PRAIRIE ISLAND NUCLEAR GENERATING PLANT
Docket No. 50-282 License No. DPR-42
50-306 DPR-60

License Amendment Request Dated December 29, 1978

Technical Specifications Associated with Use of
Exxon Nuclear Company Fuel in Prairie Island Units 1 and 2

PROPOSED CHANGES TO THE TECHNICAL SPECIFICATIONS
APPENDIX A OF OPERATING LICENSE
DPR-42 & DPR-60

Figure TS.3.10-6 DEVIATION FROM TARGET FLUX DIFFERENCE
AS A FUNCTION OF THERMAL POWER

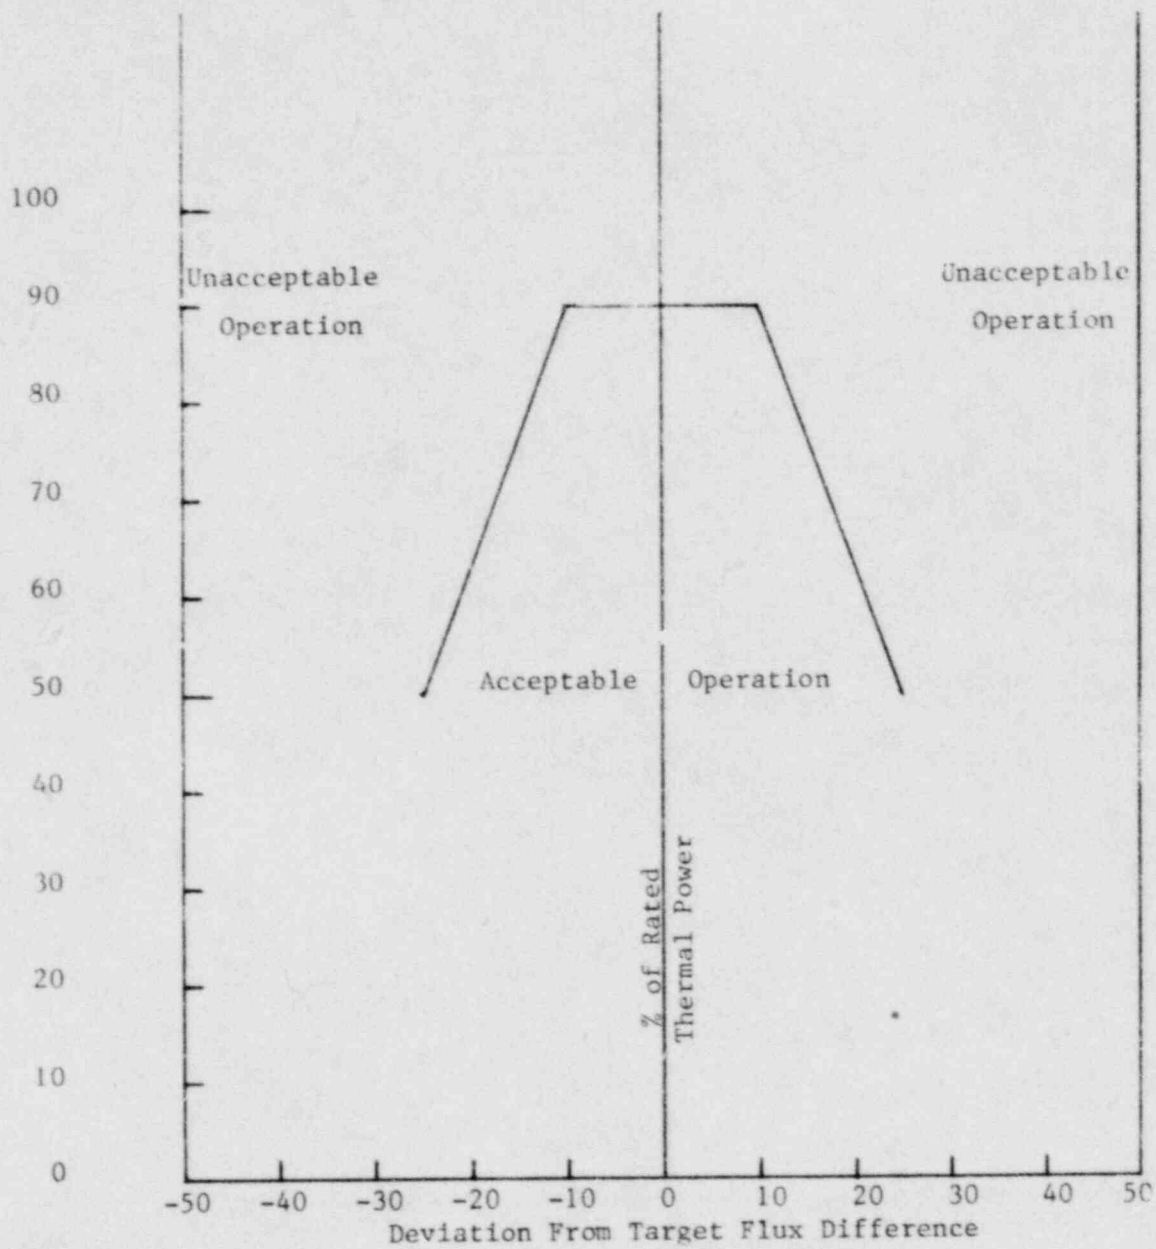
- a. Change the existing section to read as shown on pages TS.3.10-1, 1A, -2, -7A, -8, and -9 and Figure TS.3.10-6.
- b. Add Figure TS.3.10-8 of Exhibit B.

The revised Figure TS.3.10-6 is consistent with the methodology explained in Specification 3.10.B.6.

6. At a power level no greater than 90 percent of rated power,
 - a. The indicated axial flux difference may deviate from its $\pm 5\%$ target band for a maximum of one* hour (cumulative) in any 24-hour period provided that the difference between the indicated axial flux difference and the target flux difference does not exceed an envelope bounded by -10 percent and +10 percent at 90% power and increasing linearly to -25 percent and +25 percent at 50 percent power as shown in Figure TS.3.10-6.

Figure TS.3.10-8 $V(Z)$ as a function of Core Height

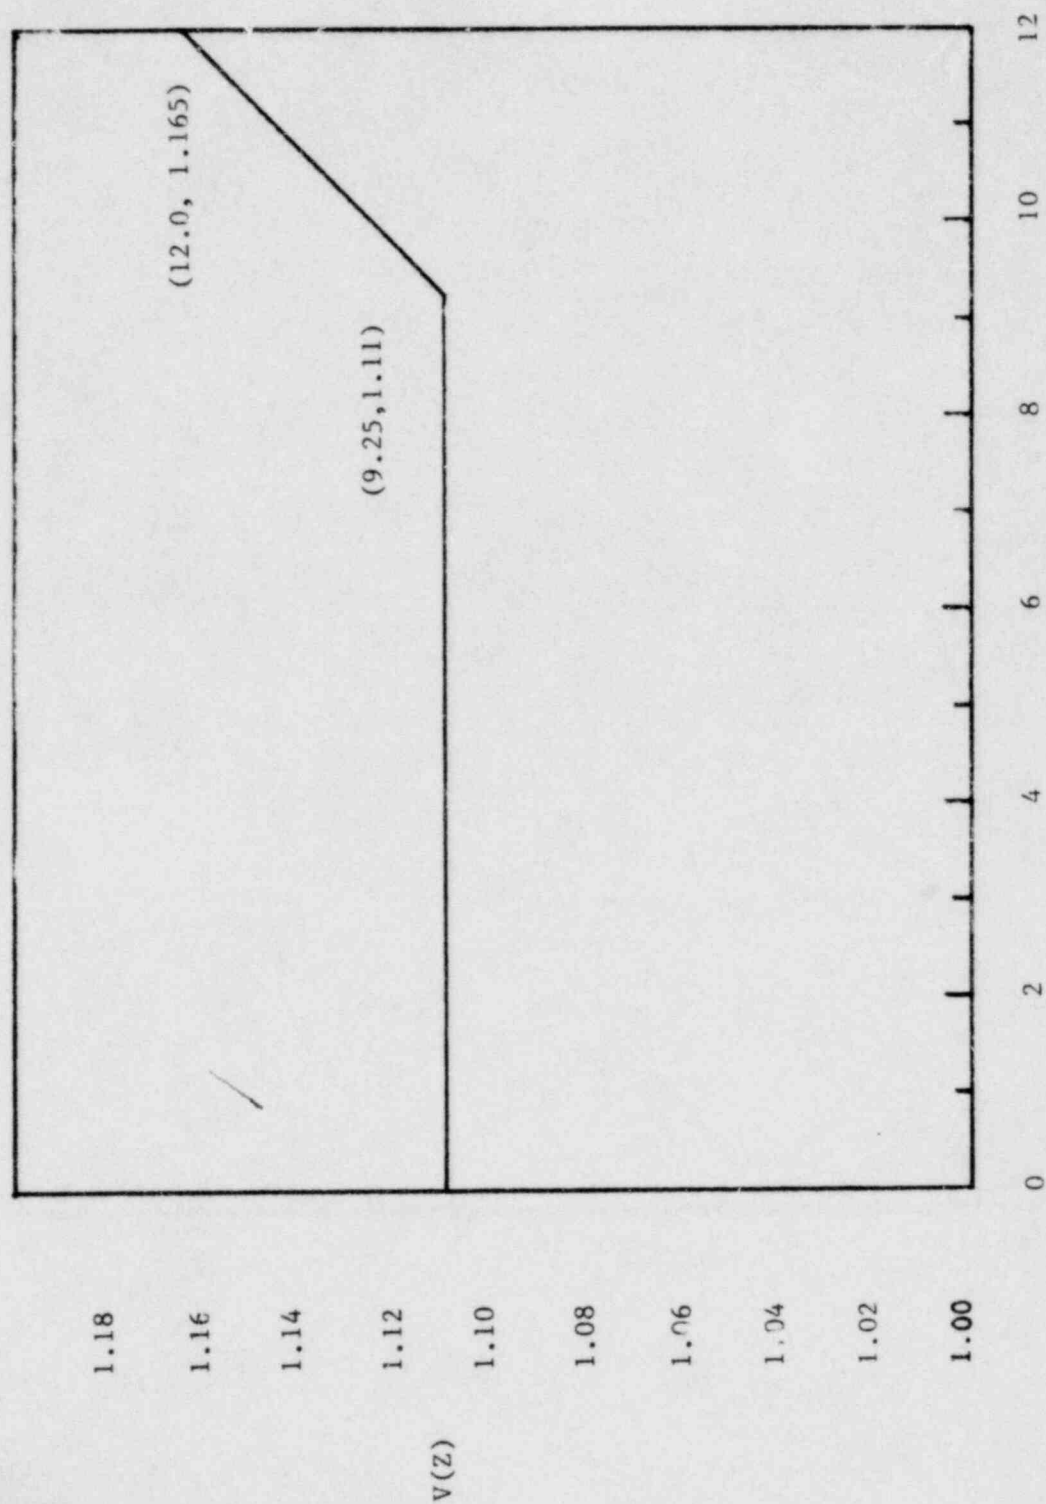
The new figure (Figure TS.3.10-8) was added to support application of the new FQ limit imposed by Specification 3.10.B.1.b.

$$F_Q^N(Z) \leq (2.145/P) \times (K(Z)/V(Z)) \quad \text{for } P > 0.5$$

- (1) P is the fraction of full power at which the core is operating
- (2) K(Z) is the function given in Figure TS.3.10-5
- (3) Z is the core height location of F_Q^N
- (4) RBP(BU) is the Rod Bow Penalty as a function of region average burnup as shown in Figure TS.3.10-7
- (5) Region is defined as those assemblies with the same loading date
- (6) V(Z) is the function given in Figure TS.3.10-8
